Notice of Allowability

Application No. 09/222,331

INVENTIONAKE PAD HOLDER

Fig.2 (AMENDED)

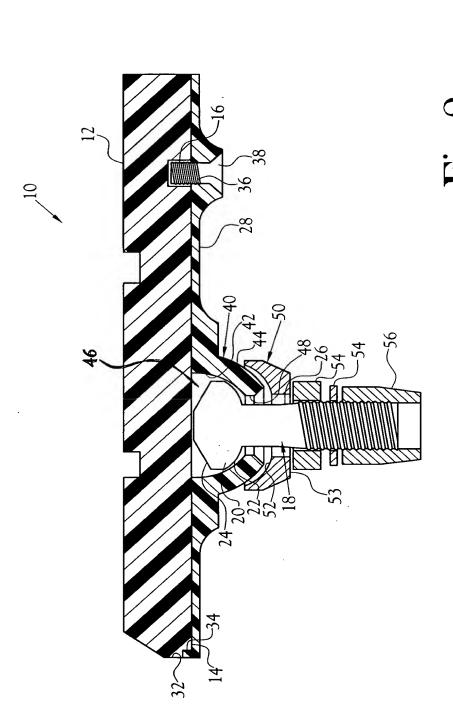
- 2. An examiner's amendment to the record appears below. Should the changes and/or additions be unacceptable to applicant, an amendment may be filed as provided by 37 CFR 1.312. To ensure consideration of such an amendment, it MUST be submitted no later than the payment of the issue fee.
- 3. The following changes to the drawings have been approved by the examiner and agreed upon by applicant: cavity 46 referenced on page 9 line 12 of the specification is now shown in Figure 2. In order to avoid abandonment of the application, applicant must make these above agreed upon drawing changes.
- 4. The following is an examiner's statement of reasons for allowance:
